**From:** James Munroe  
**Sent:** Friday, 1 December 2023 10:45 AM  
**To:** tiffany.robinson@richmondvalley.nsw.gov.au; council@richmondvalley.nsw.gov.au  
**Cc:** Gavin Ho; CommunityEngagement  
**Subject:** Statutory Council Notification for 64-70 Stapleton Avenue, Casino 2470

**Subject:** Proposed Residential Development (residential flat building and multi-dwelling housing) – 64-70 Stapleton Avenue, Casino NSW 2470.

**From:** Jessica Ind <Jessica.Ind@richmondvalley.nsw.gov.au>  
**Sent:** Wednesday, 24 January 2024 9:14 AM  
**To:** Gavin Ho  
**Cc:** Melinda Budd  
**Subject:** RE: 64-71 Stapleton Avenue, Casino - Council comments

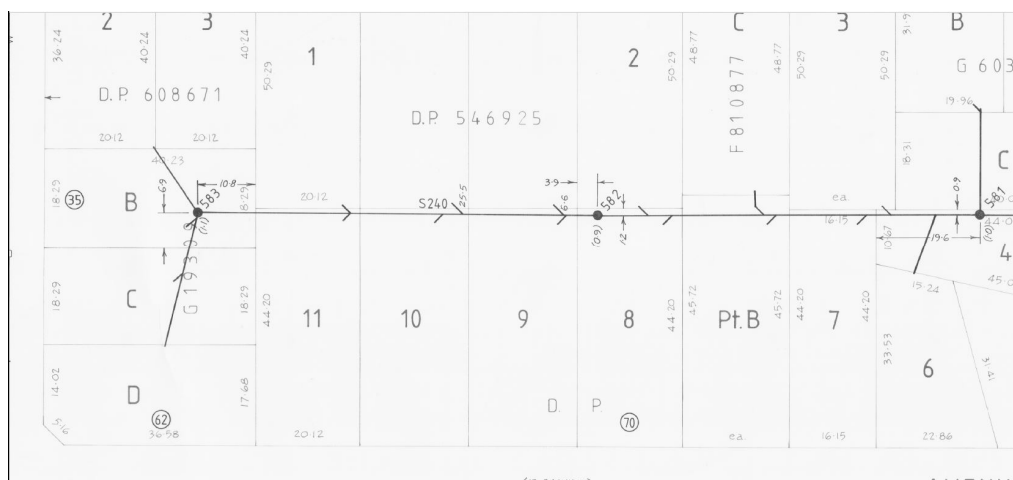
- The whole development will need to meet the NSW Fire Safety Guidelines, particularly fire hydrant coverage. Typical fire hydrant coverage for residential development is a 30m distance from an existing hydrant to the fire appliance, and a 90m distance from the fire appliance to the edge of proposed buildings. The distances measured must be along the actual anticipated location of the fire hose line (not 'as the crow flies').
- A Section 68 application and approval will be required for the private water connection back to the public water infrastructure.

## Stormwater

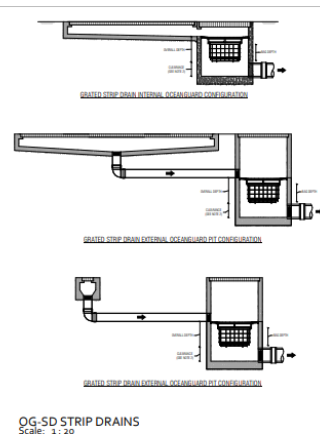
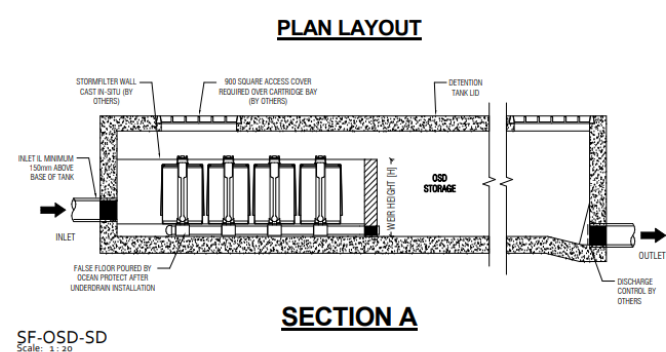
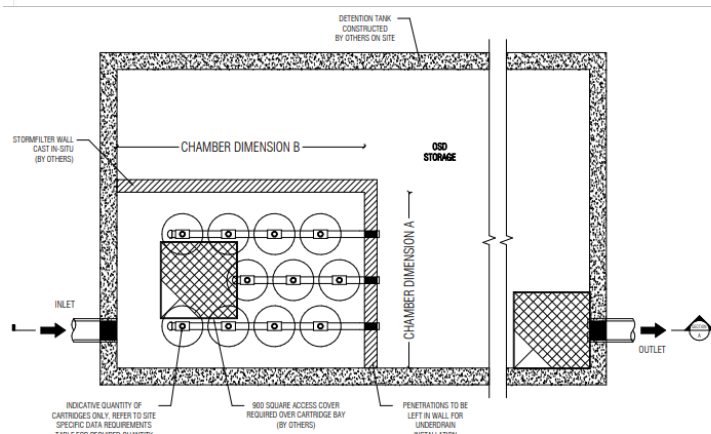
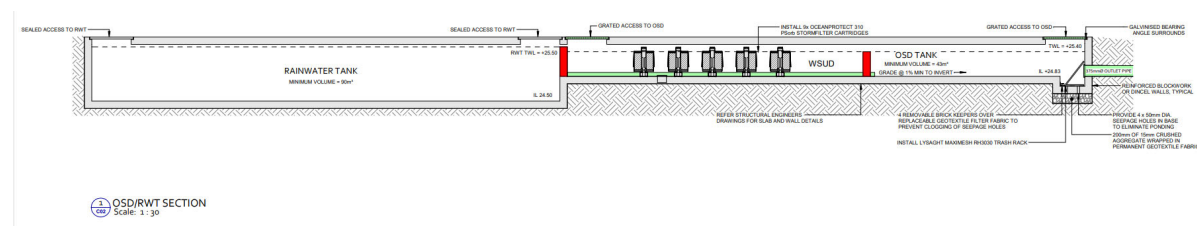
- While there is no formal Stormwater Management Plan (SMP) the design plans of the stormwater infrastructure clearly show that the on-property network is well in excess of the standards for quality and quantity controls, hence is accepted.
- The grate access to the WSUD tank, OSD tank and rainwater tank all should be locked to mitigate public access for safety reasons.
- Can the twin 150 RHS back to the kerb be flatter to mitigate intrusion in the road verge adjacent to 72 Stapleton Av?
